UNITED STATES
NUCLEAR REGULATORY COMMISSION
WASHINGTON, D. C. 20555

February 25, 1981

SUBJECT: RESEARCH INFORMATION LETTER - #115
INDEPENDENT ASSESSMENT OF TRAC-P1A COMPUTER CODE

Figure 1. Difference Between the Predicted and the Measured Peak Clad Temperature as Function of Test Facility Scale

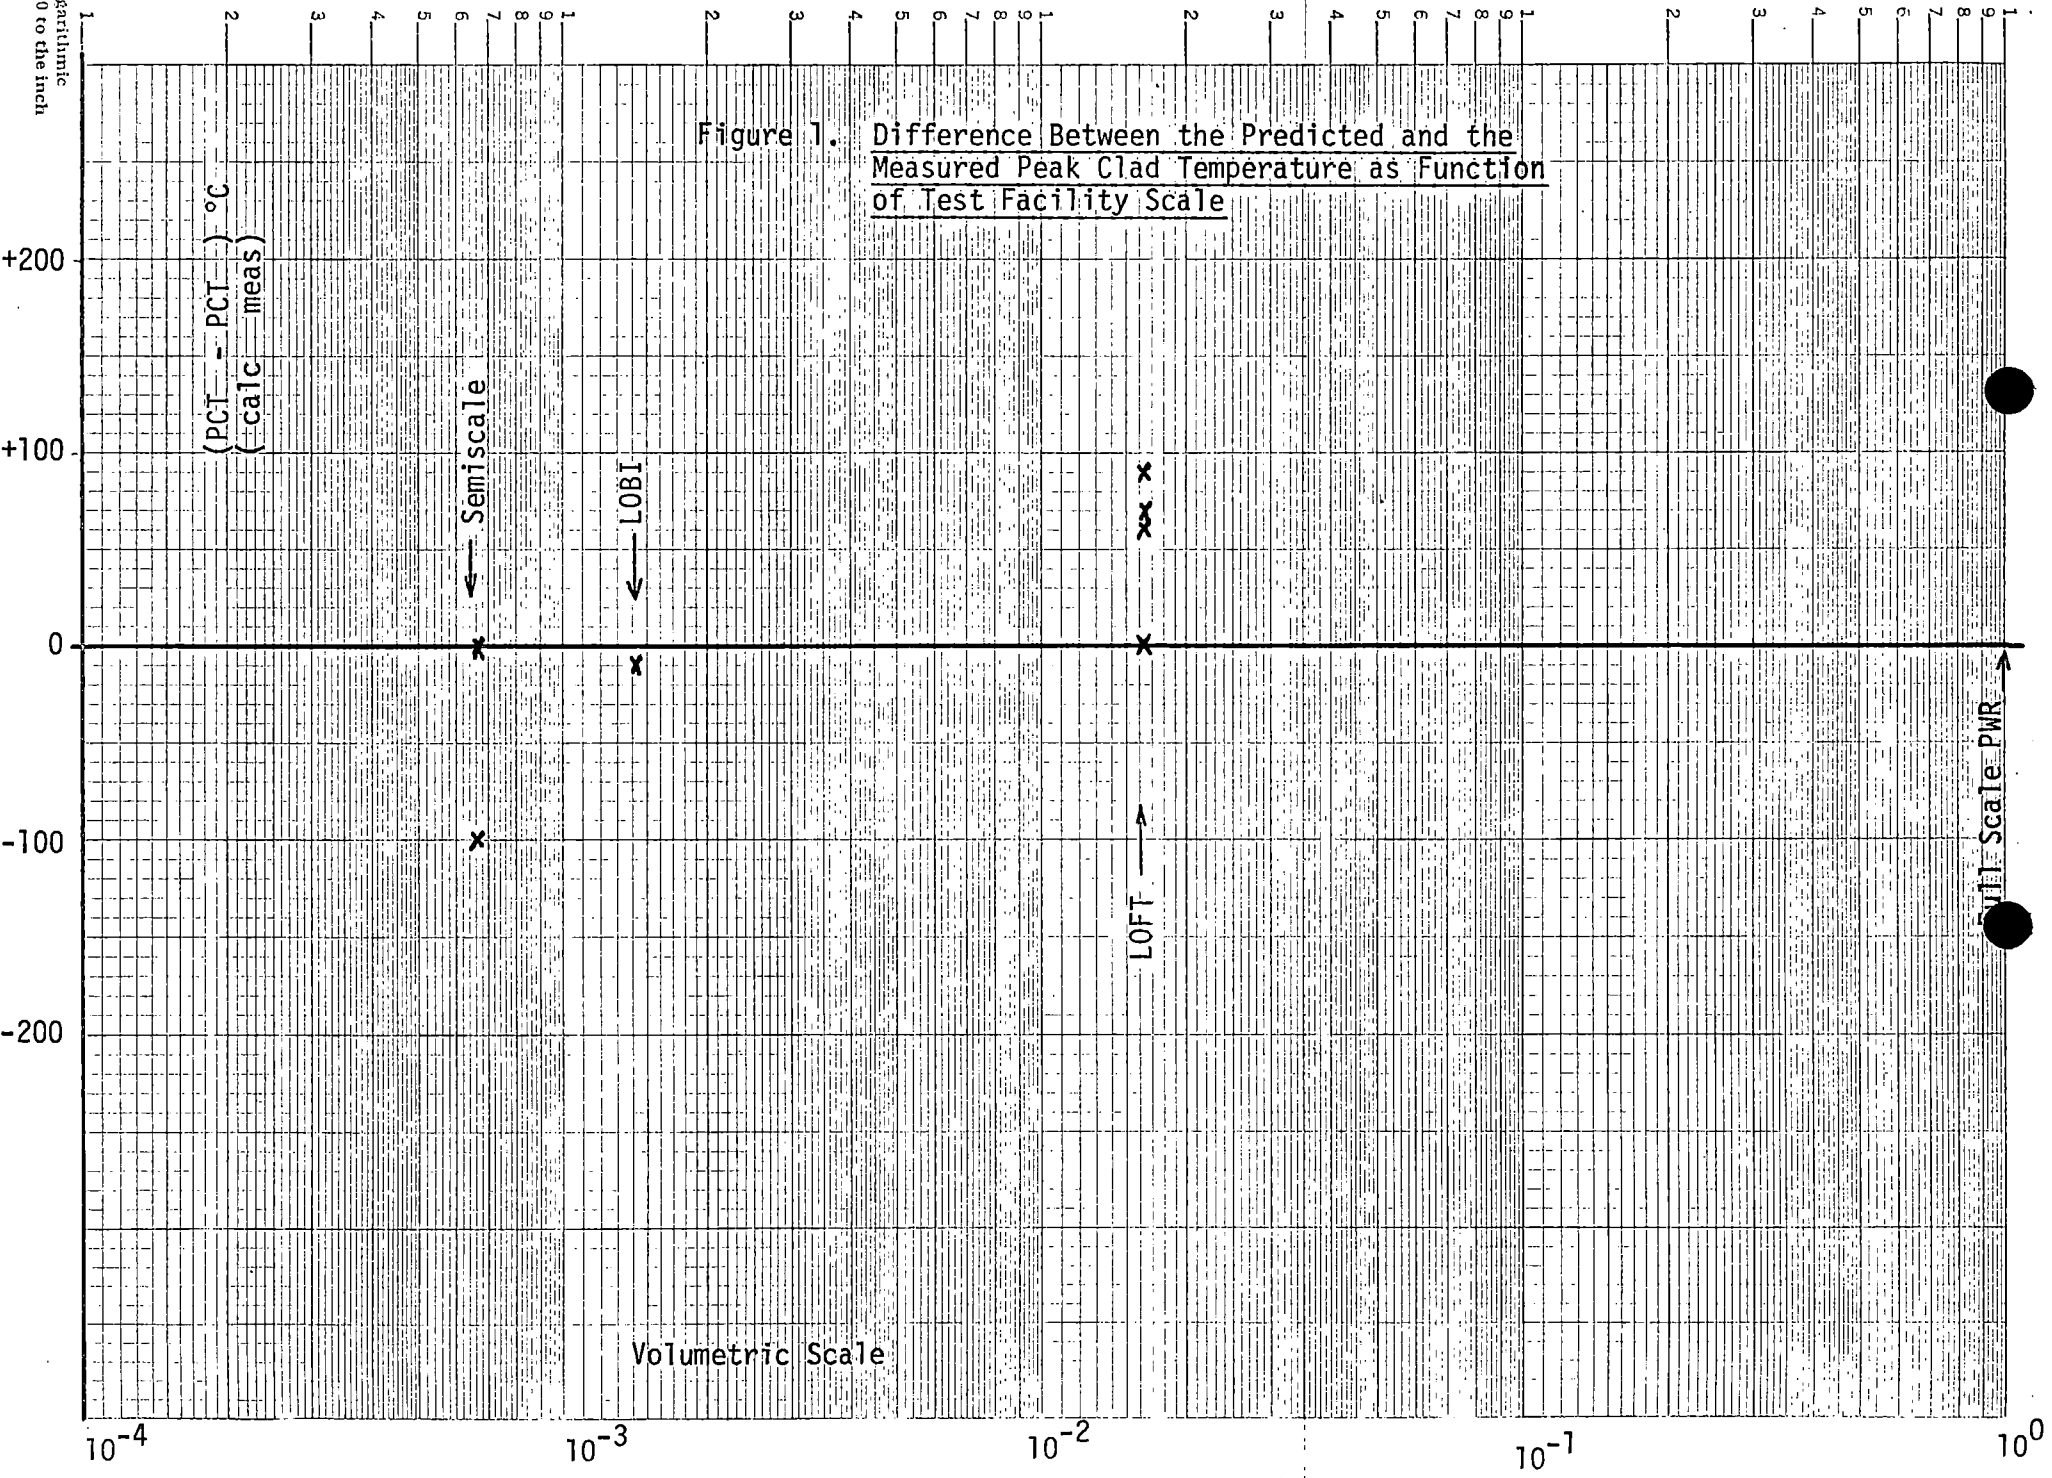
Information on the predictive capabilities of the TRAC-PIA code reported in this Research Information Letter provides a reference for gauging the progress made with future versions of TRAC. Figure 1 illustrates the uncertainty in the TRAC-PIA prediction of the peak clad temperature (PCT) for the integral systems tests addressed in this assessment, as a function of the test facility scale. Extrapolation to full scale provides a very rough guidance regarding the uncertainty in the prediction of PCT for LOCA in PWR plants. Reliability of this type of information will improve as more cases are addressed in the assessment of future code versions.

Information on the predictive capabilities of the TRAC-PIA code reported in this Research Information Letter provides a reference for gauging the progress made with future versions of TRAC. Figure 1 illustrates the uncertainty in the TRAC-PIA prediction of the peak clad temperature (PCT) for the integral systems tests addressed in this assessment, as a function of the test facility scale. Extrapolation to full-scale provides a very rough guidance regarding the uncertainty in the prediction of PCT for LOCA in PWR plants. Reliability of this type of information will improve as more cases are addressed in the assessment of future code versions.
